Swansboro Country Airport

El Dorado County

January 14, 2019

Photograph 1 - Penetrations of the Primary Surface

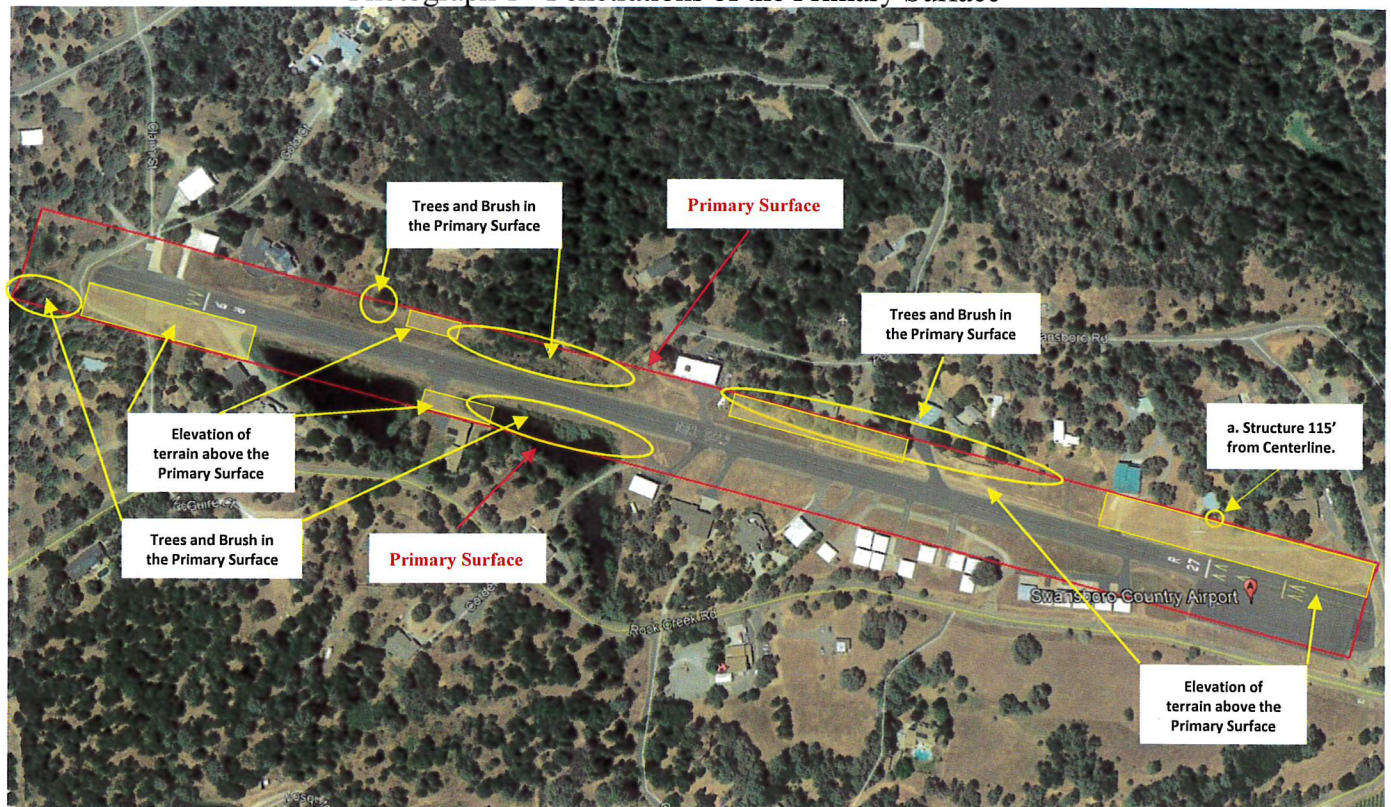
2. Structures, trees, brush, and areas of high ground along both sides and down the entire length of Runway 9/27 are within the Federal Aviation Regulation (FAR) Part 77, Primary Surface (please see enclosed Photographs 1 through 7). The Primary Surface extends 200 feet beyond each runway end, 125 feet each side of the runway centerline, with an elevation equal to the nearest point on the runway centerline. Although, some of the following items were varianced for aircraft parking we recommend mitigating each to the degree possible:

Photograph 3 - Pole and Structure 118 feet north of Runway 9/27 penetrates the Primary Surface.

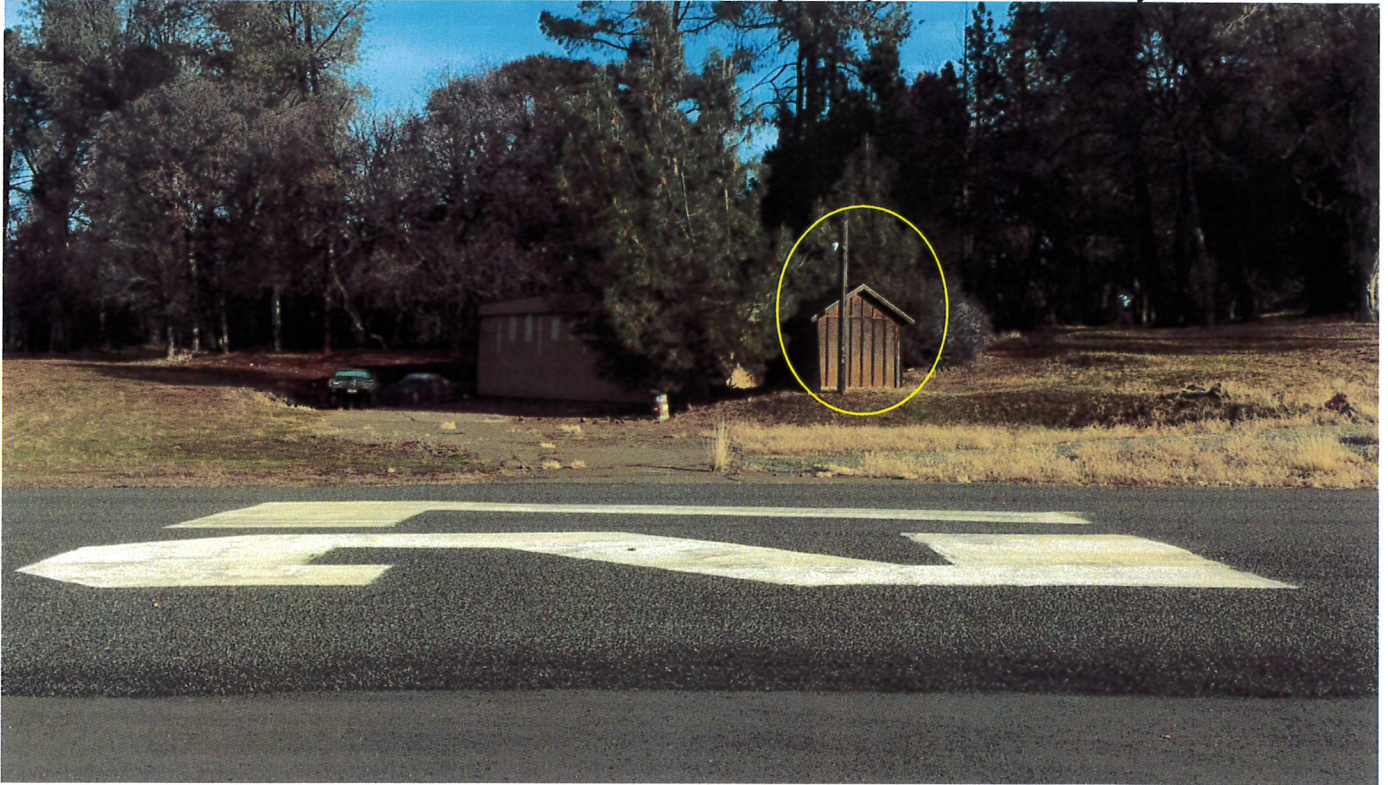
- b. A utility pole and a structure abeam and 115 feet north of the Runway 27 Displaced Threshold penetrates the Primary Surface by 10 feet (please see enclosed Photograph 3). We recommend you work with the homeowner and the power provider to relocate the pole and structure clear of the primary surface.

Photograph 5 - Penetrations of the Primary Surface near the abandoned VASI.

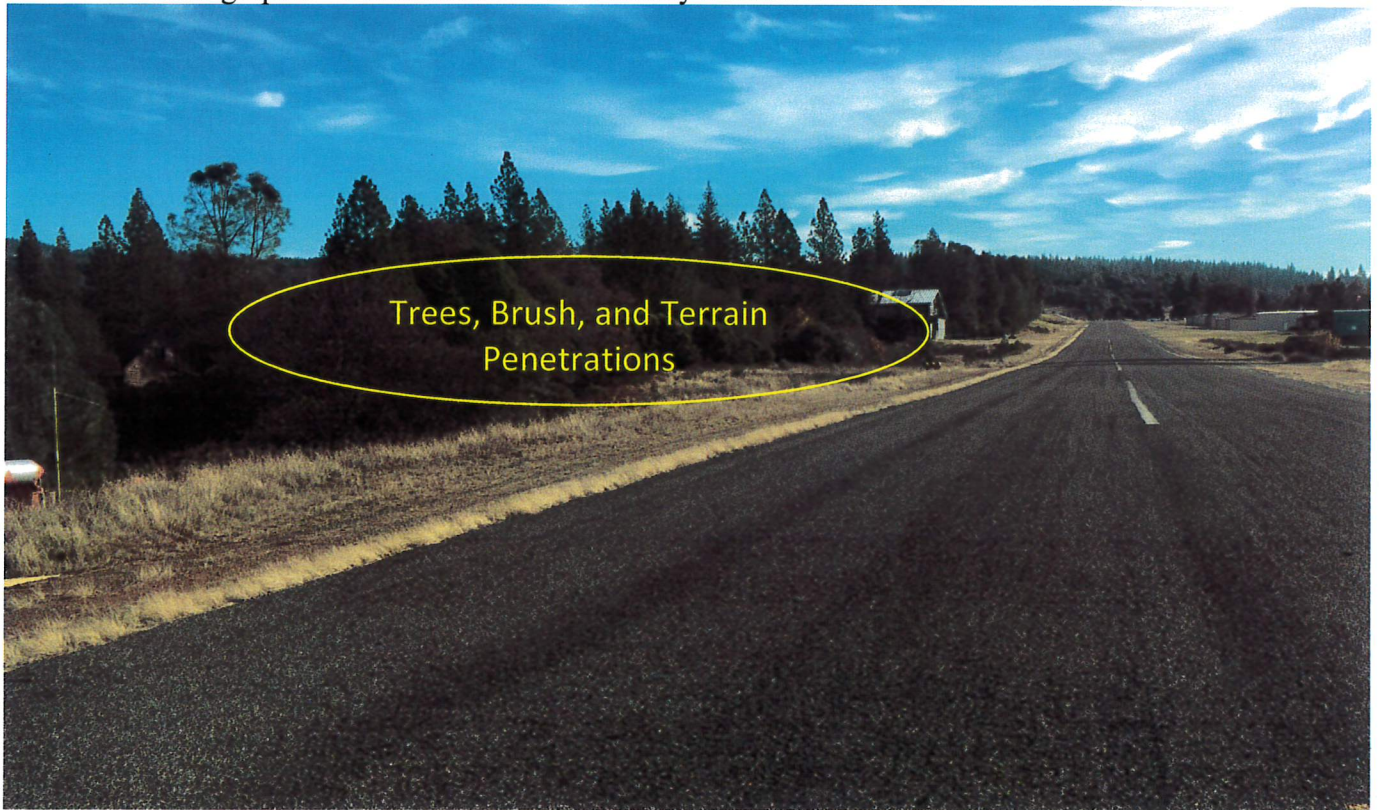
- d. Small trees, brush, and high ground penetrate the Primary Surface on the north side of the runway from 450 to 885 feet east of the Runway 9 Displaced Threshold (please see enclosed Photograph 5). Although Lot 60 is varianced for aircraft parking, at a minimum this area should be kept clear of trees and brush.

Photograph 8 – Trees, brush, and high ground penetrate the Approach and Transitional Surfaces.

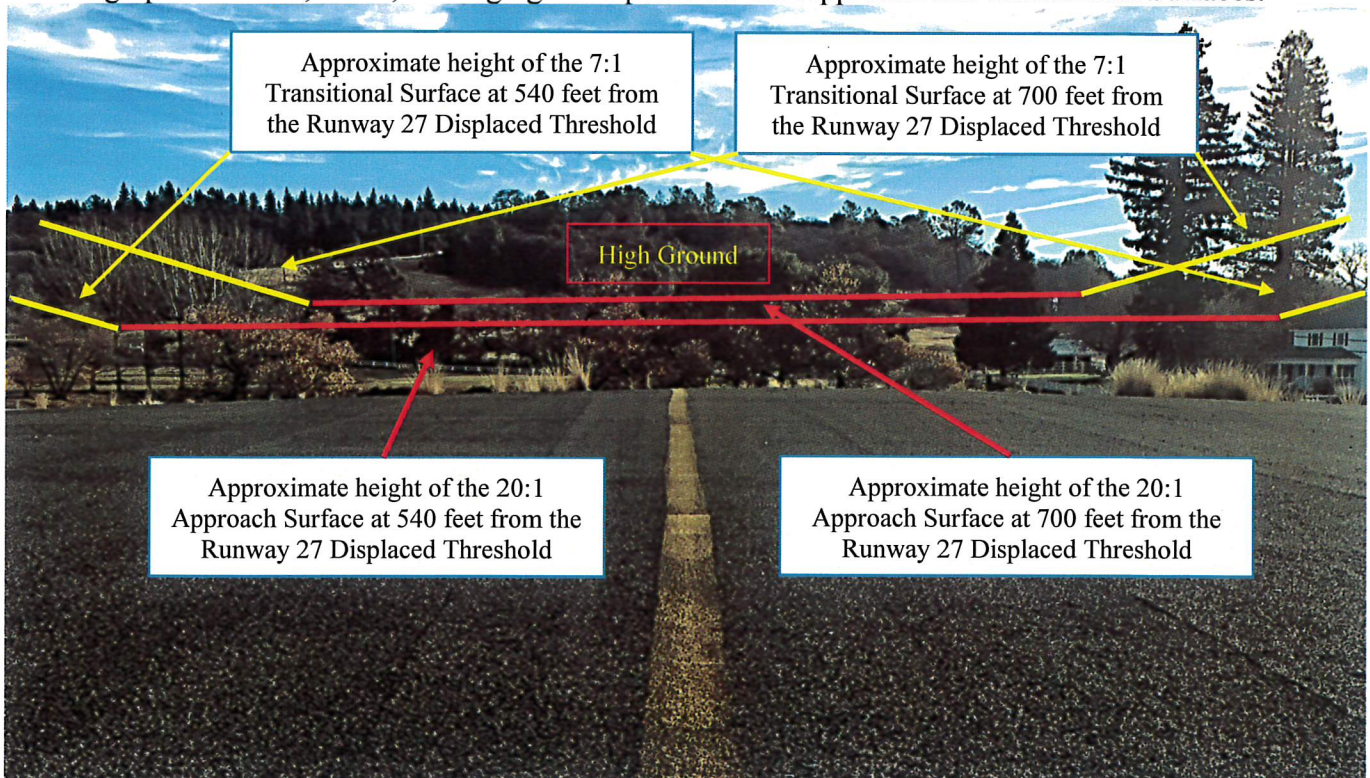
3. Trees and high ground from the Runway 27 Displaced Threshold to 950 feet east of the Displaced Threshold penetrate the FAR Part 77, 20:1 Approach and 7:1 Transitional Surfaces (please see enclosed Photograph 8). Trees and high ground in the Approach and Transitional Surfaces were varianced in 1978. However, the trees have grown significantly in the intervening 41 years, coupled with high ground north of the Displaced Threshold and 950 feet east of the Displaced Threshold penetrating the Approach Surface, and now constitute a potential hazard to approaching traffic. We recommend that the trees be trimmed as shown in enclosed Photograph 8 or be removed, and the area from the Displaced Threshold to Sluice Street graded down as close to the runway centerline elevation as possible to provide a clear approach for incoming traffic.

Photograph 10 - Trees and brush penetrate the 20:1 Approach and 7:1 Transitional Surface.

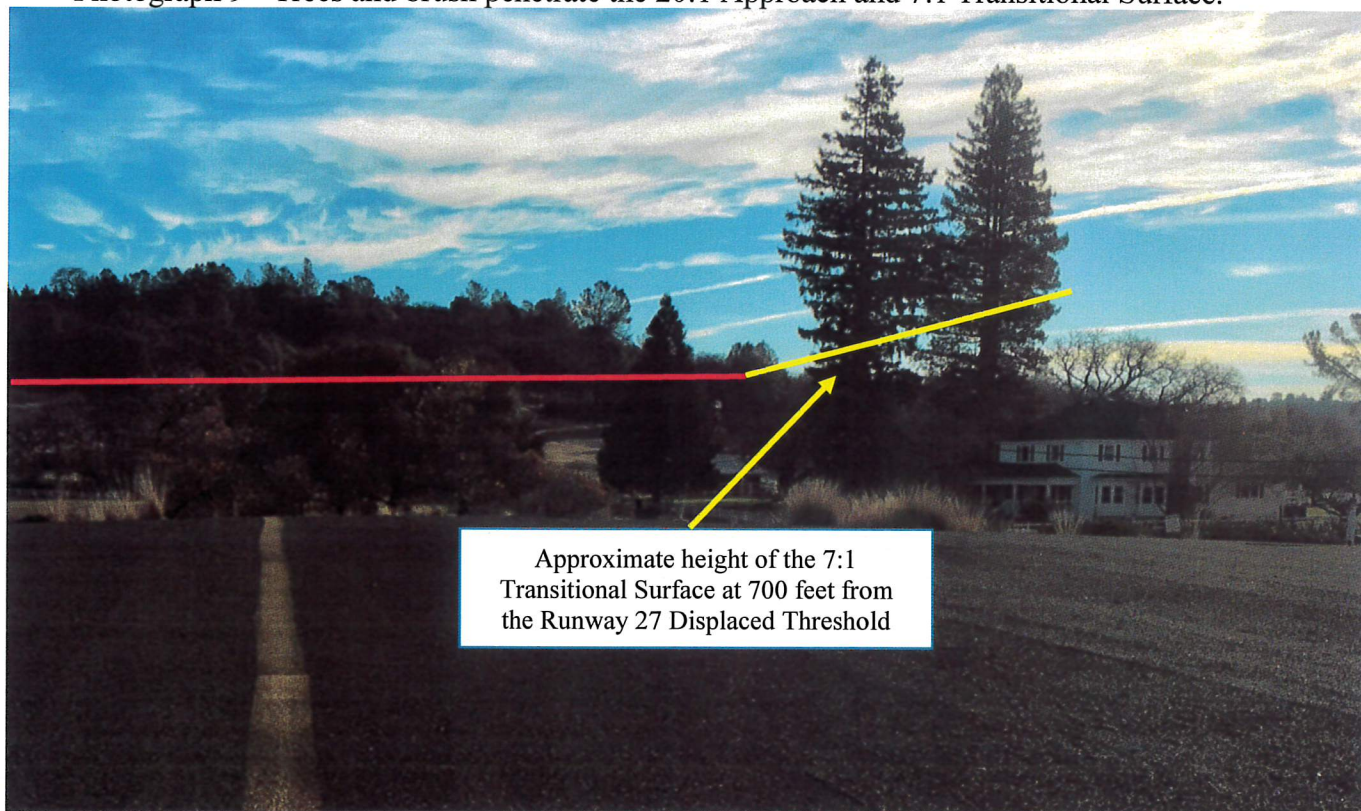
5. Trees, brush, and terrain 75 to 550 feet west of the Runway 9 Displaced Threshold penetrate the FAR Part 77, 20:1 Approach and the 7:1 Transitional Surfaces. Although, a variance exists for aircraft parking in Lots 10 and 718, terrain penetrates the Approach Surface at 75 feet west of the Runway 9 Displaced Threshold to the runway end as close as 55 feet south from the runway centerline. We recommend this area be graded level to the elevation of the runway centerline to provide a clear approach for incoming traffic. Additionally, both Transitional Surfaces are varianced, however, many trees are taller than when the variance was granted in 1978 with many trees now penetrating both the Approach and Transitional Surfaces by more than 50 feet. At a minimum, trees in the Approach Surface must be trimmed, and Transitional Surface penetrations should be trimmed as shown in enclosed Photograph 10 or be removed.

Photograph 11 – Looking west, trees and brush penetrate the 7:1 Transitional Surface.

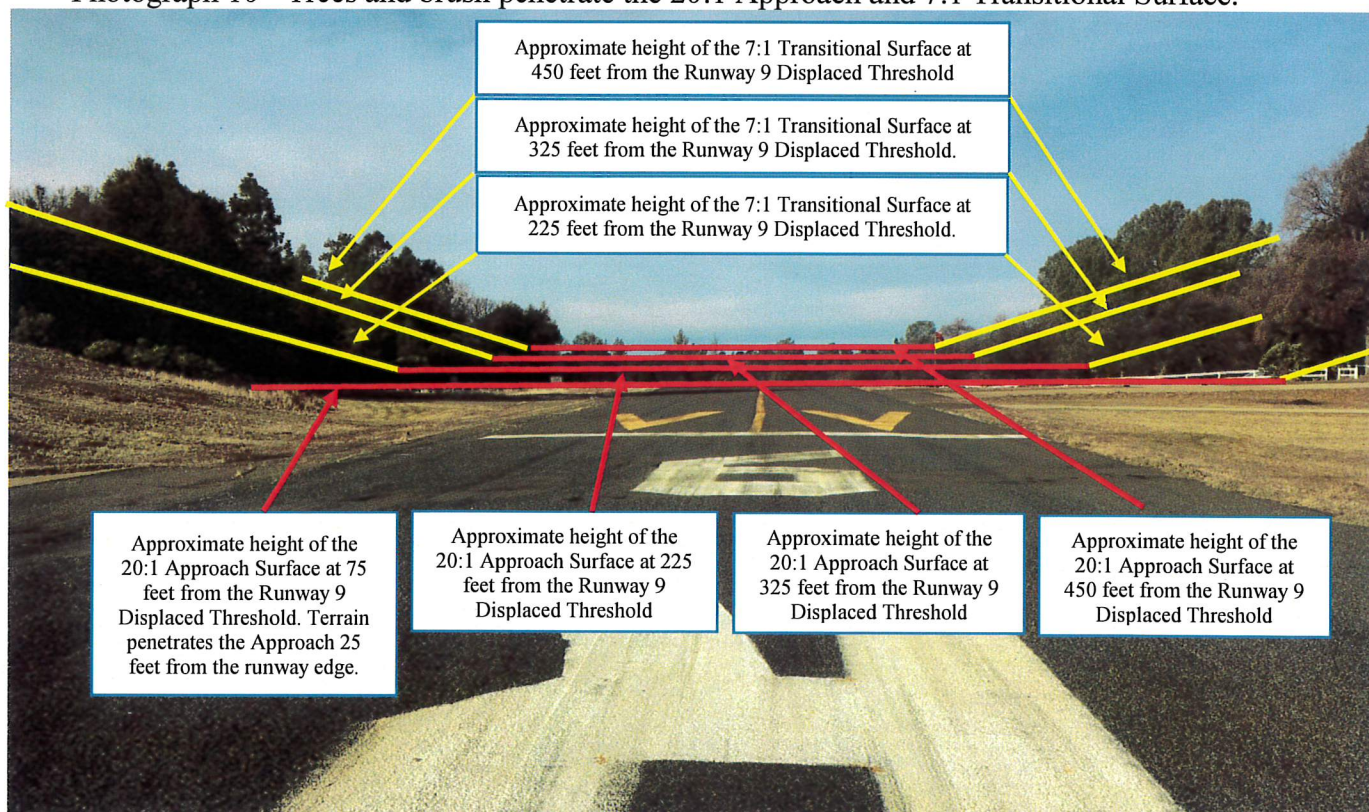
6. Structures, trees, brush, and areas of raised terrain on both sides and down the entire length of Runway 9/27 penetrate the FAR Part 77, Transitional Surface. Trees, high ground, a hangar, and parked aircraft in the Transitional Surfaces are varianced on both sides of the runway. However, comparing photographs taken during the inspection (please see enclosed Photographs 11 and 12) to those taken in 1976, trees adjacent to the runway have grown in number and are substantially higher. We recommend that these trees be trimmed as shown in enclosed Photographs 11 and 12 or be removed to be clear of the Transitional Surface as soon as possible.
